UNITED STATES PATENT AND TRADEMARK OFFICE

APPLICATION NO.	FILING DATE	FIRST NAMED INVENTOR	ATTORNEY DOCKET NO.	CONFIRMATION NO.
10/709,877	06/02/2004	Kevin P. Pearce		3876
35585	7590	11/30/2005		
KEVIN P. PEARCE 136 SHENKLEVIEW DRIVE JOHNSTOWN, PA 15905			EXAMINER RODRIGUEZ, WILLIAM H	
			ART UNIT	PAPER NUMBER
			3746

Office Action Summary	Application No. 10/709,877	Applicant(s) PEARCE, KEVIN P.	
	Examiner William H. Rodriguez	Art Unit 3746

DETAILED ACTION

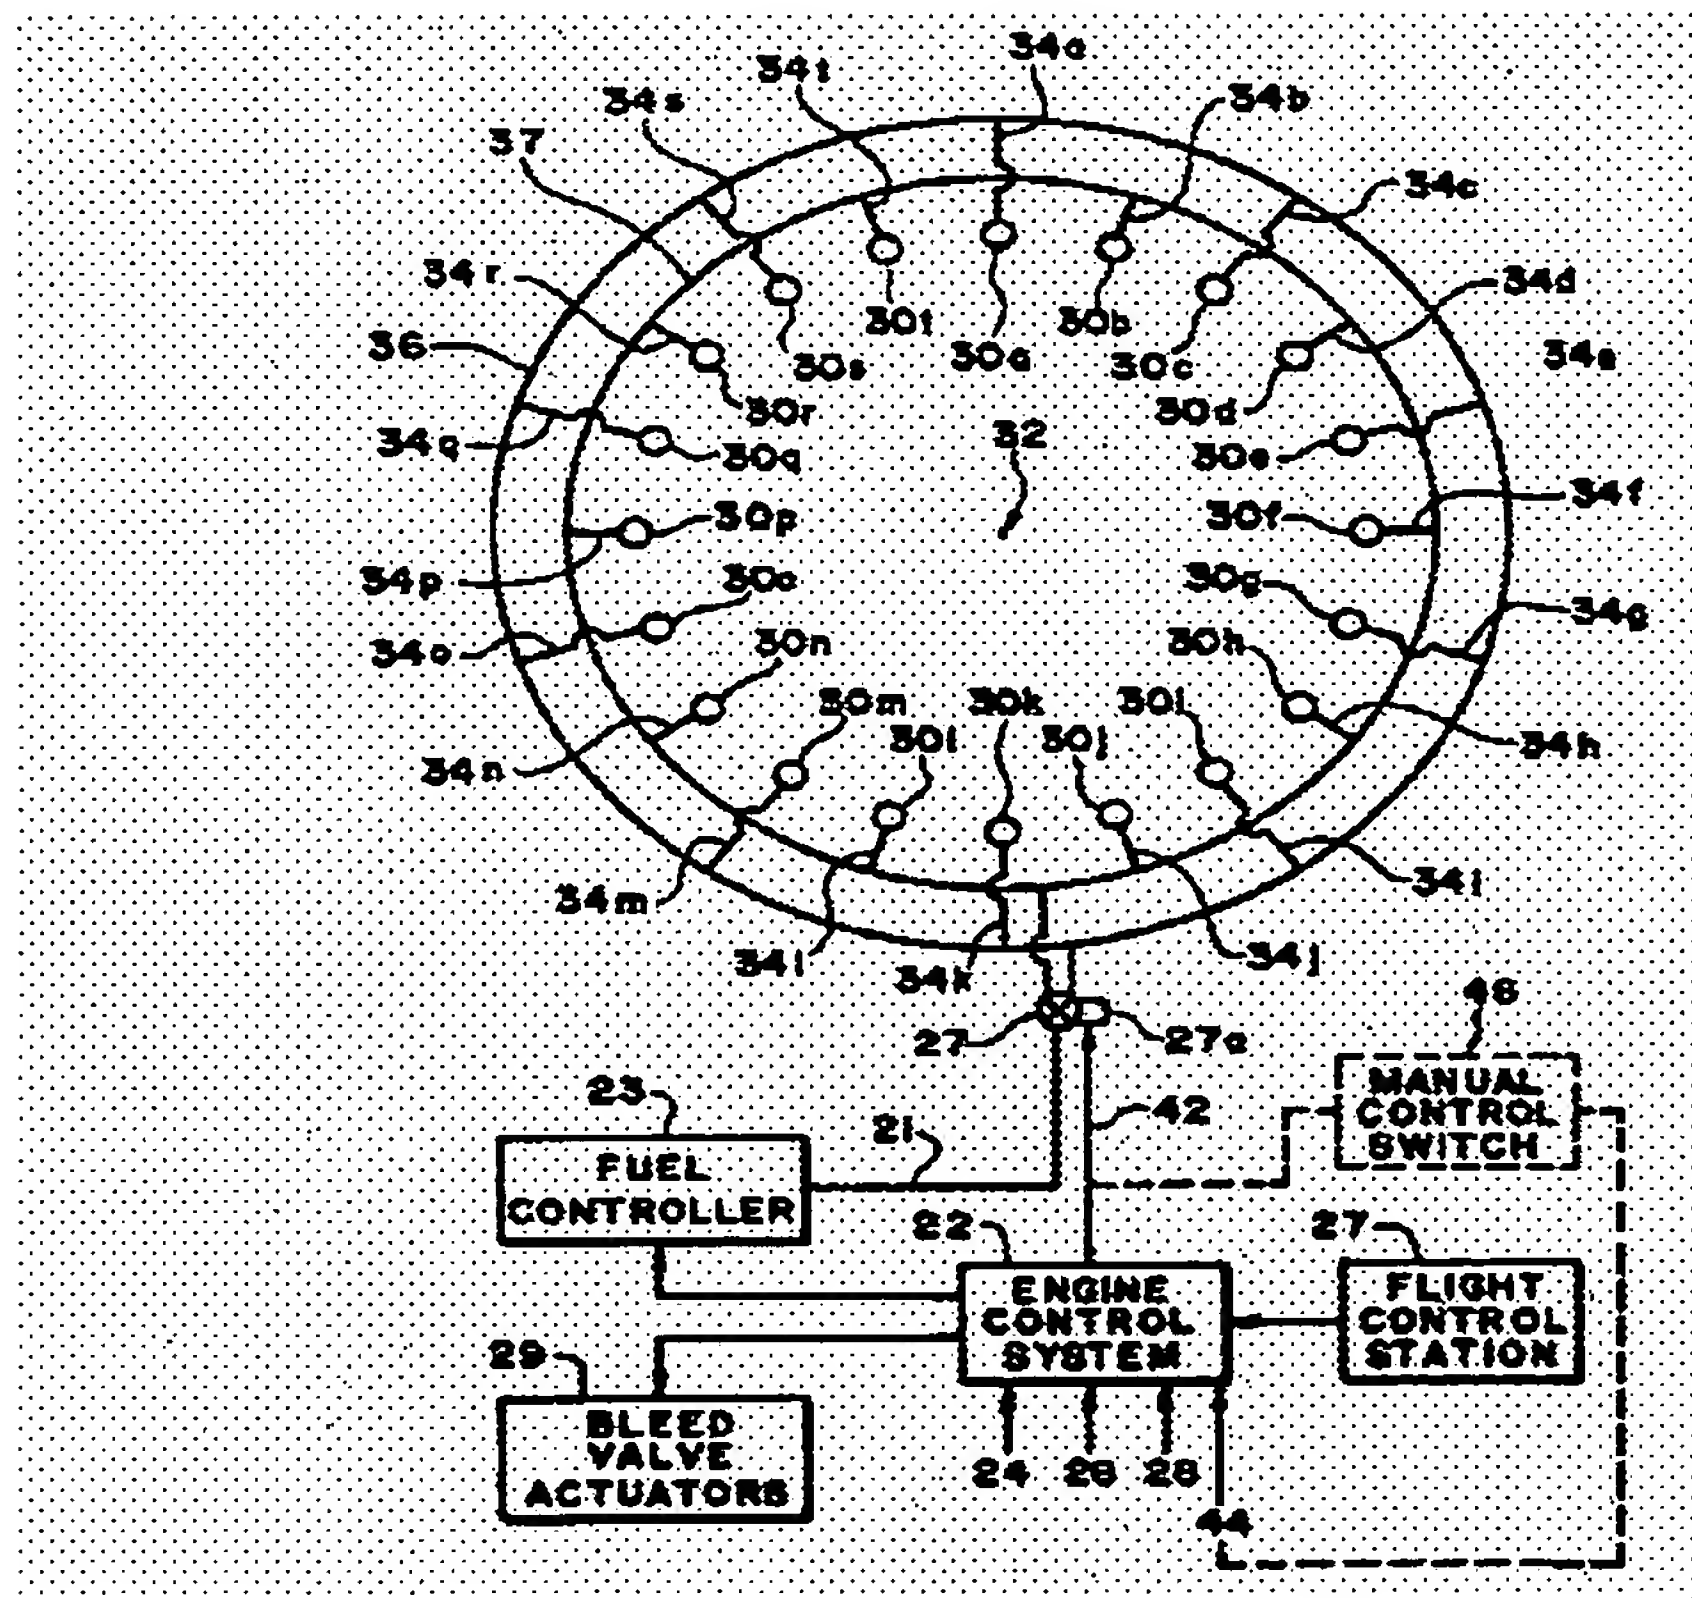
Figures 5a and 5b show 4 or 6 independent fuel injectors distributed around the circumference of the combustion chamber (typical arrangement in the art). However, these fuel injector are not grouped in any way.

*According to the Merriam Webster's Collegiate Dictionary, group means two or more elements assembled together or having a unifying relationship. In figures 5a and 5b, two or more fuel injectors are not assembled together or having a unifying relationship. The fuel injectors are independently assembled around the circumference of the combustion chamber, they are not grouped in any way.

As an example of what the examiner is requesting regarding the drawings, refer to the figures of US 5,205,116.

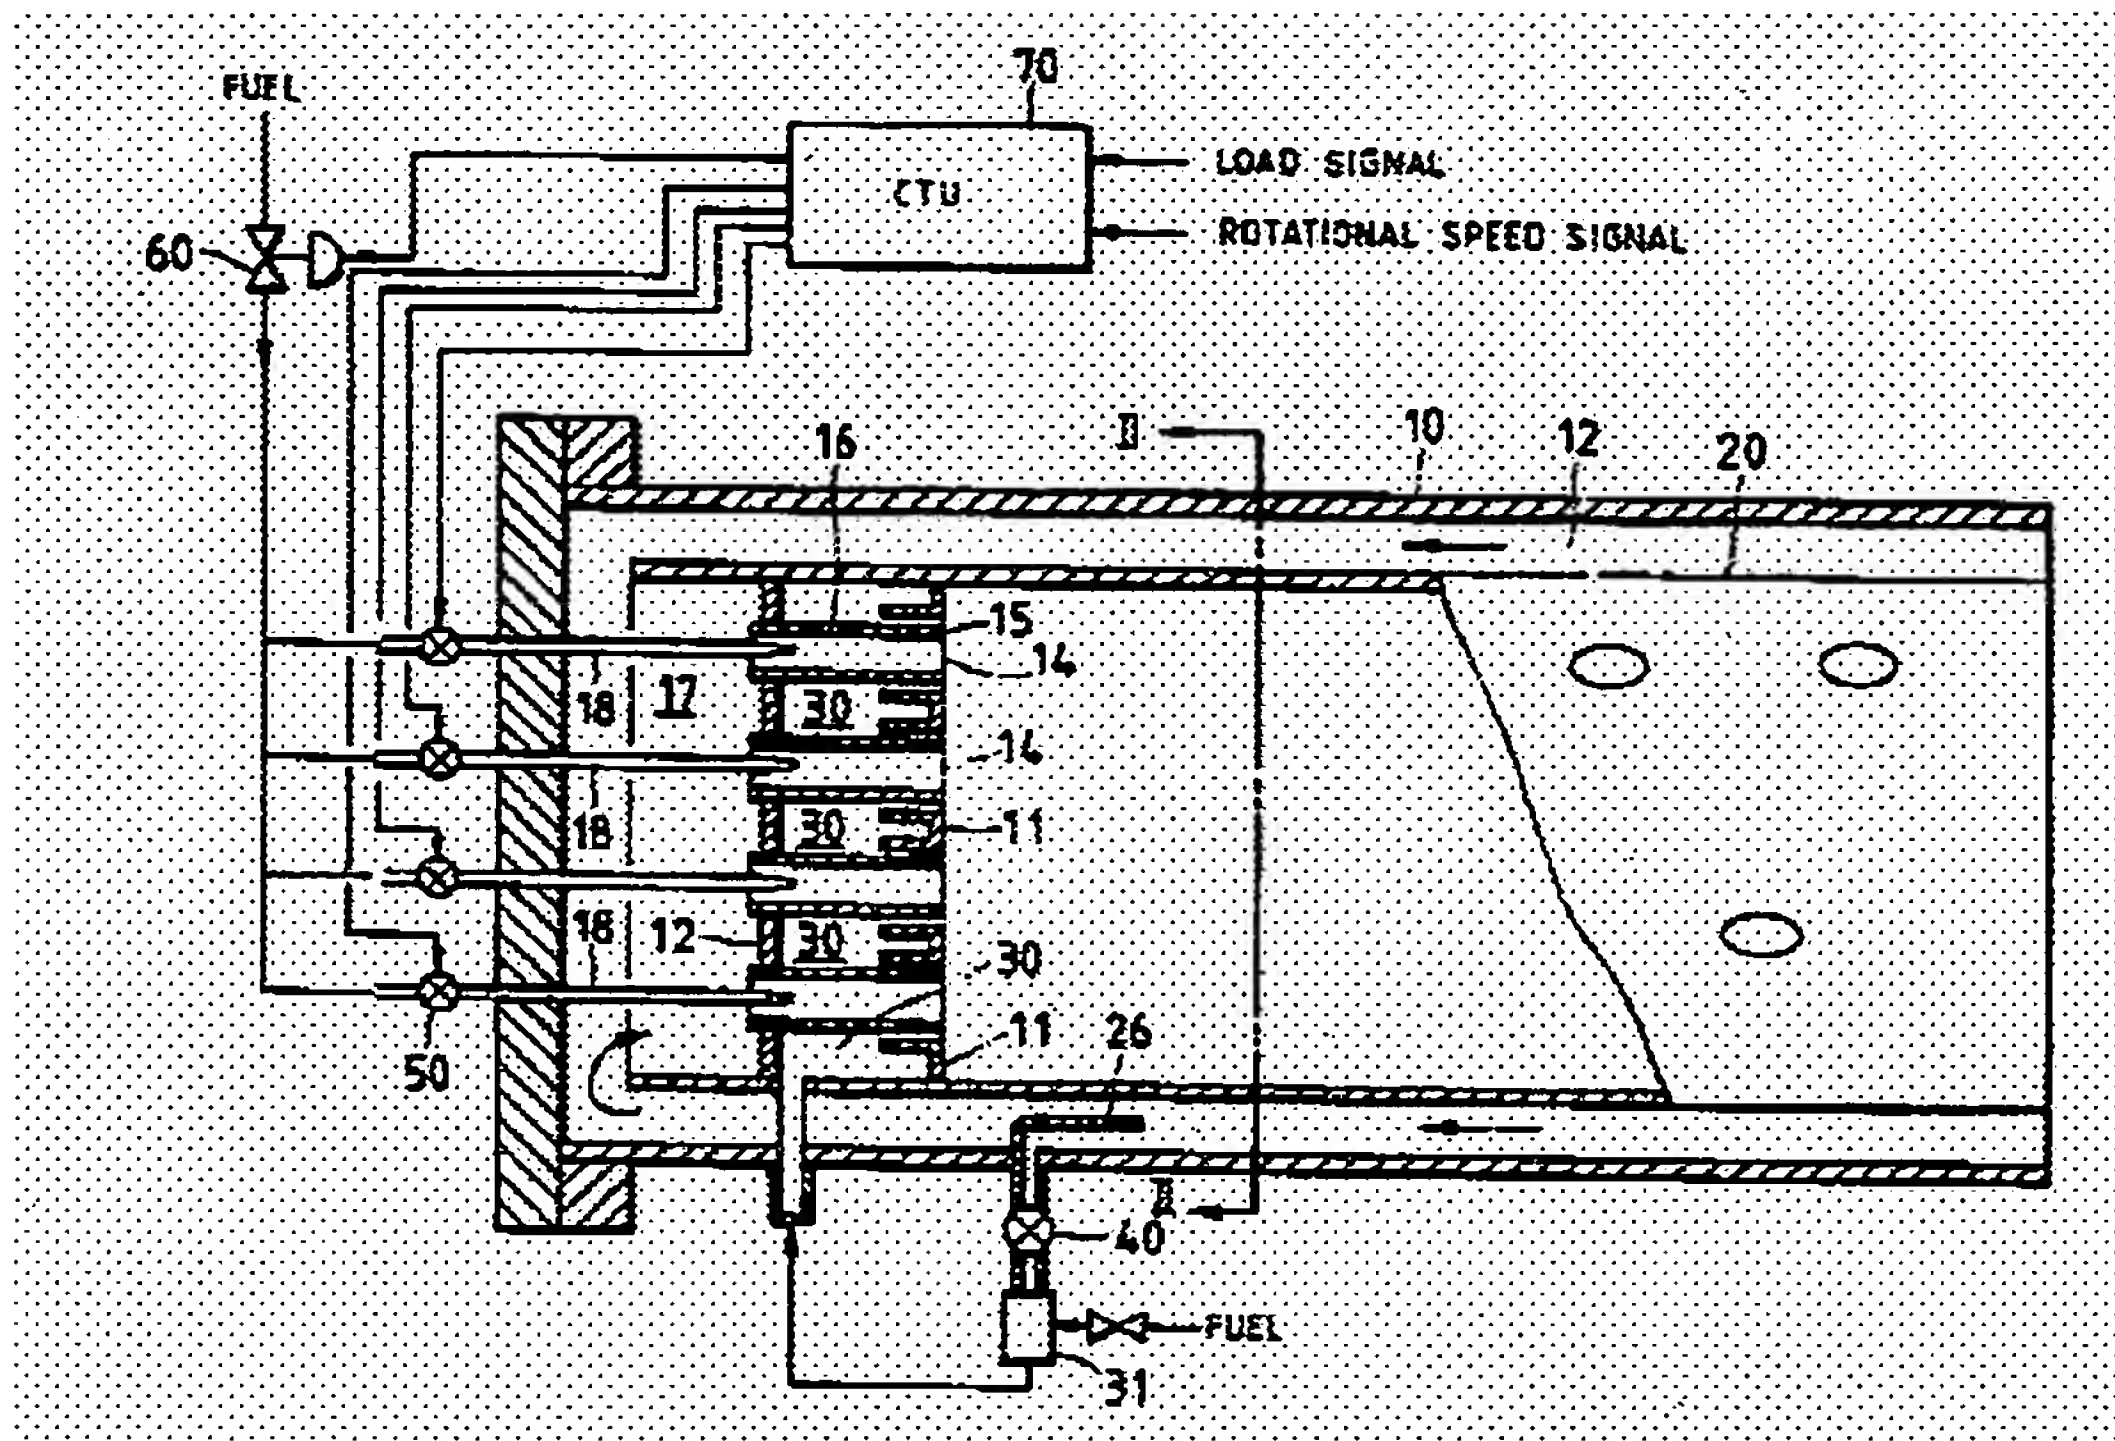
As clearly shown in Figure 3 of Ng, the programmable electronic control unit 22 receives sensor signals 24, 26, 28 from sensors detecting operational parameters (i.e., load, speed, temperature, etc, see cl.3 ll.48-54) of the turbine engine. Then, these sensor signals received from the sensors are compared to their desired values. Based on the difference the controller sends a signal to the fuel controller 23 to adjust the fuel injection through the fuel injectors accordingly. Ng's fuel injectors are arranged as the ones disclosed and claimed in the invention. See particularly **Figures 1, 3**.
